Groundwater Transfer Review Summary Form

Transfer/PA # I- <u>14550</u>
GW Reviewer <u>Grayson Fish</u> Date Review Completed: <u>11/12/2024</u>
Summary of Same Source Review:
☐ The proposed change in point of appropriation is not within the same aquifer as per OAR 690-380-2110(2).
Summary of Water Level Decline Condition Review:
☐ Water levels at the original point(s) of appropriation have exceeded the allowed decline threshold defined by conditions in the originating water right.
Summary of Injury Review:
☐ The proposed transfer will result in another, existing water right not receiving previously available water to which it is legally entitled or result in significant interference with a surface water source as pe 690-380-0100(3).
Summary of GW-SW Transfer Similarity Review:
☐ The proposed SW-GW transfer doesn't meet the definition of "similarly" as per OAR 690-380-2130.
This is only a summary. Documentation is attached and should be read thoroughly to understand the basis for determinations.

1. Basic description of the changes proposed in this transfer: The applicant proposes to add an APOA KLAM 14789 to Certificate 74458. No changes in POU are proposed. KLAM 14789 is an autho

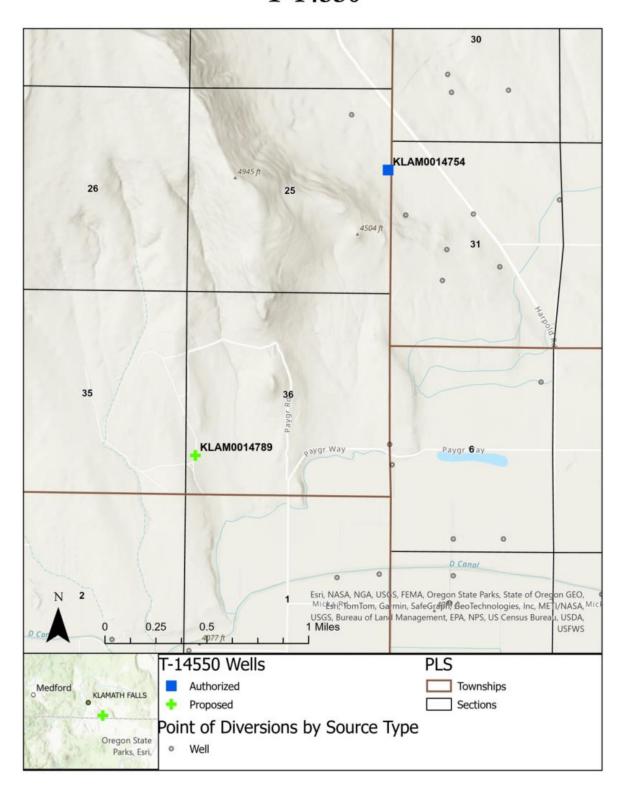
- 2. Will the proposed POA develop the same aquifer (source) as the existing authorized POA? X Yes \square No Comments: Both the authorized POA and proposed APOA source water from the predominantly volcanic units at depth. Both wells showed very similar water level elevations (within 5 feet) and trend prior to measurements at KLAM 14789 were ceased in 2013, see attached hydrograph.
- 3. a) Is the existing authorized POA subject to a water level decline condition? \square Yes \boxtimes No Comments: There is no water level decline condition for Certificate 74458.
